RE: 1105 Front Street NE – The Cannery (Reference No. 24-106451-PLN) Completeness Response

Reference Nos.: 24-106451-PLN (Class 3 Site Plan Review, Tentative Subdivision Plan, Class 1 & 2 Adjustment, Class 2 Driveway Approach Permit)

PRELIMINARY SITE PLAN
THE CANNERY
FUND
SALEM, OREGON

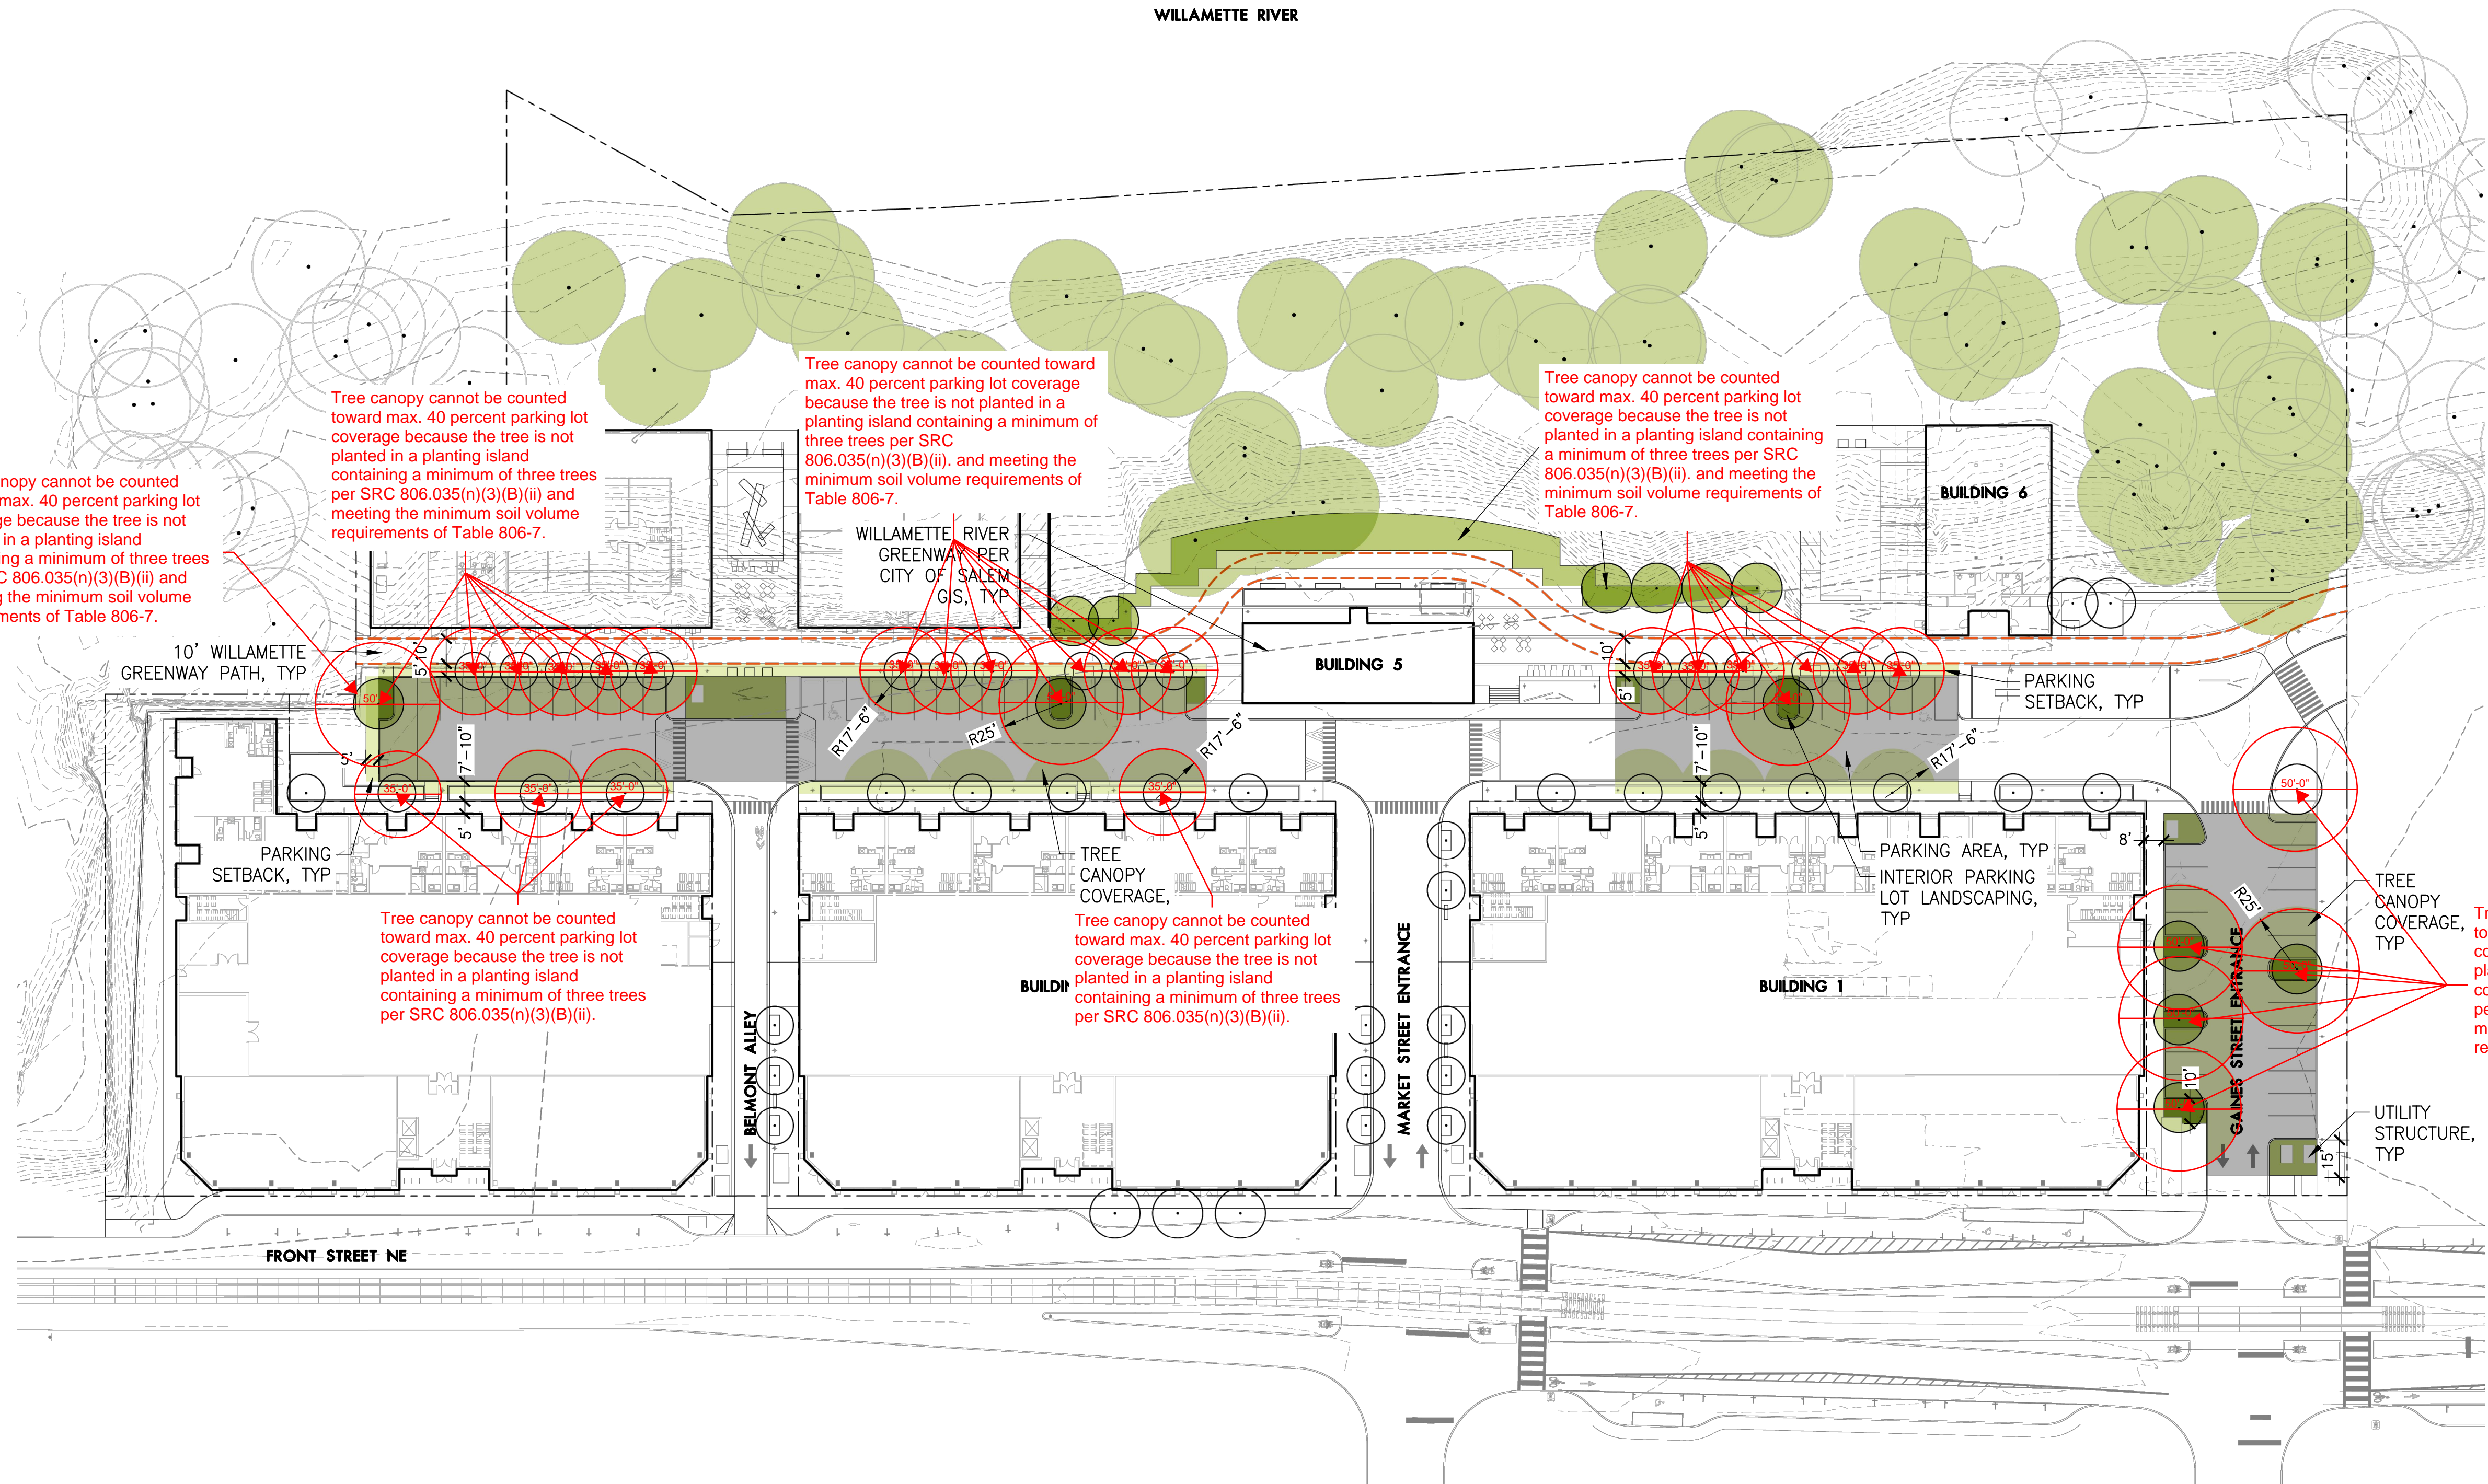
Tree canopy cannot be counted toward max. 40 percent parking lot coverage because the tree is not planted in a planting island containing a minimum of three trees per SRC 806.035(n)(3)(B)(ii) and meeting the minimum soil volume requirements of Table 806-7.

Tree canopy cannot be counted toward max. 40 percent parking lot coverage because the tree is not planted in a planting island containing a minimum of three trees per SRC 806.035(n)(3)(B)(ii) and meeting the minimum soil volume requirements of Table 806-7.

Tree canopy cannot be counted toward max. 40 percent parking lot coverage because the tree is not planted in a planting island containing a minimum of three trees per SRC 806.035(n)(3)(B)(ii) and meeting the minimum soil volume requirements of Table 806-7.

Tree canopy cannot be counted toward max. 40 percent parking lot coverage because the tree is not planted in a planting island containing a minimum of three trees per SRC 806.035(n)(3)(B)(ii) and meeting the minimum soil volume requirements of Table 806-7.

Tree canopy cannot be counted toward max. 40 percent parking lot coverage because the tree is not planted in a planting island containing a minimum of three trees per SRC 806.035(n)(3)(B)(ii).

Tree canopy cannot be counted toward max. 40 percent parking lot coverage because the tree is not planted in a planting island containing a minimum of three trees per SRC 806.035(n)(3)(B)(ii).

Tree canopy cannot be counted toward max. 40 percent parking lot coverage because the tree is not planted in a planting island containing a minimum of three trees per SRC 806.035(n)(3)(B)(ii) and meeting the minimum soil volume requirements of Table 806-7.

Response: A revised Landscape Land Use Diagram is provided in Attachment D. Tree planning islands have been revised to include at least three trees and to meet soil requirements. The parking lot tree canopy coverage is now 42 percent of the total parking area, exceeding the required 40 percent canopy coverage. This item is met.

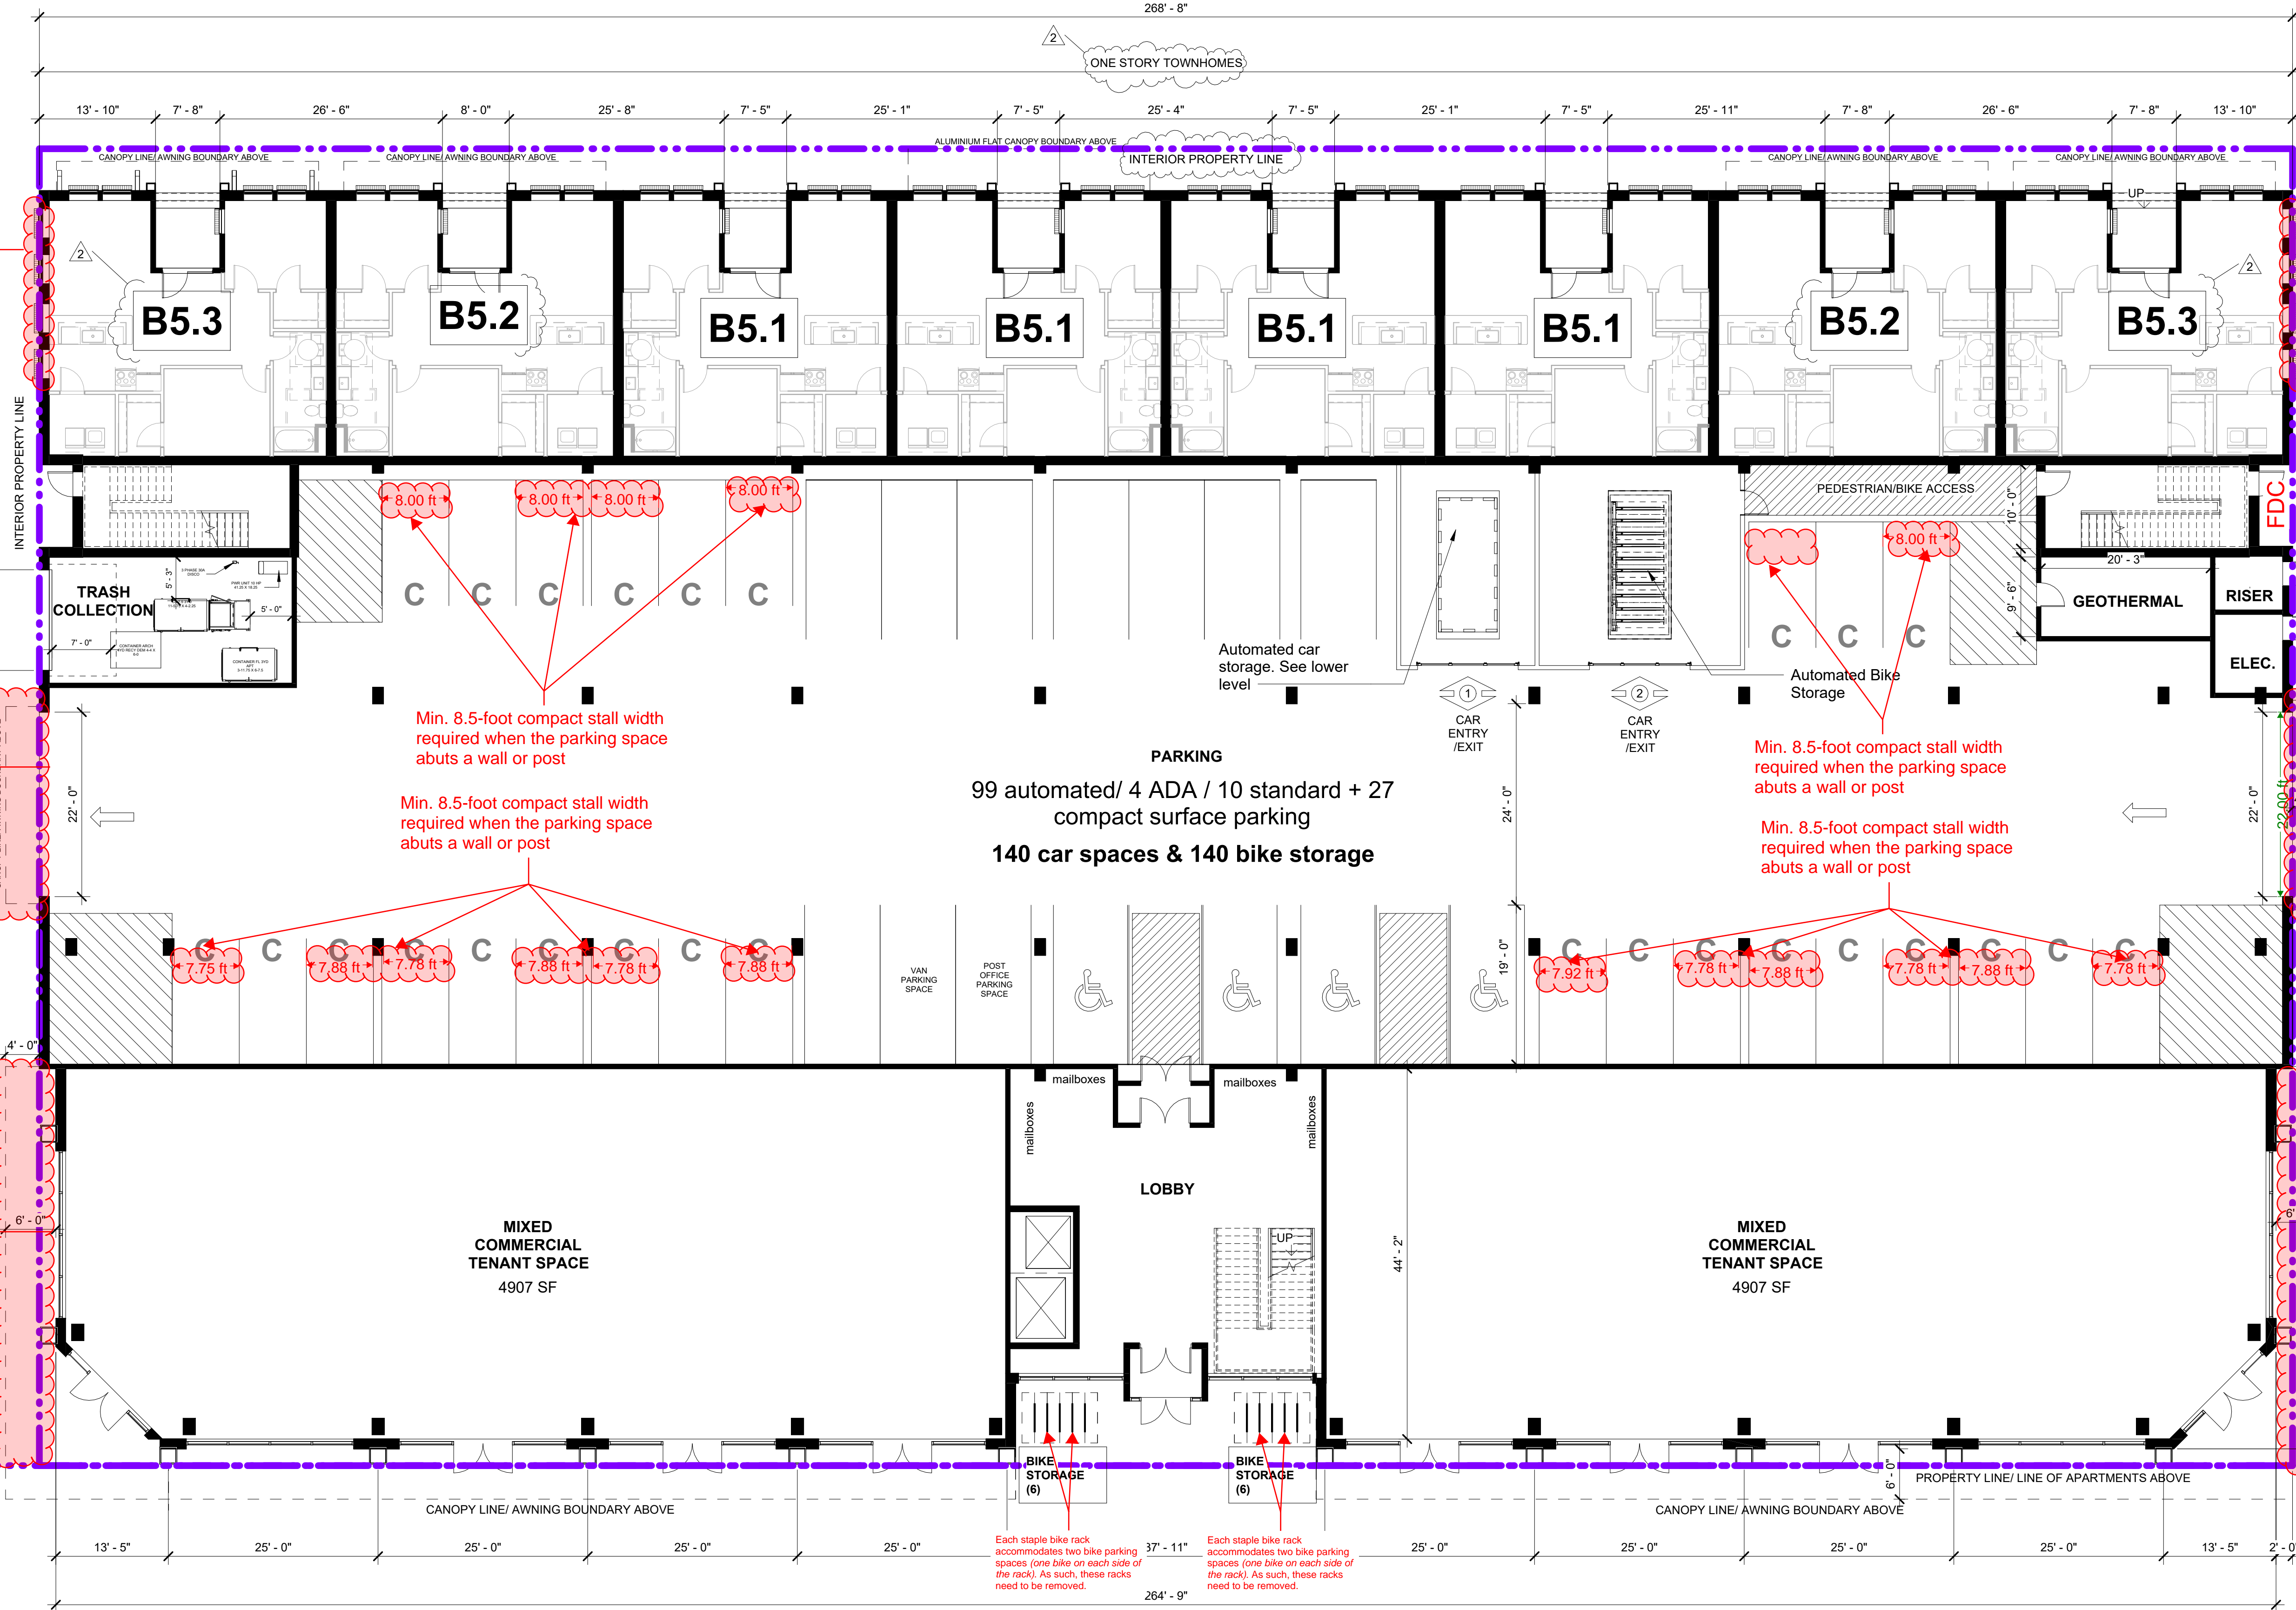
It appears that portions of the building project over the property line. Confirmation required if this will be allowed under the building code.

Response: Planned property lines have been modified such that no canopies, balconies, or living space project across a property line as detailed on the revised Preliminary Building Elevations and Floor Plans in Attachment E. The 6th floor living space that projected into the Front Street NE right-of-way has been modified. This item is met.
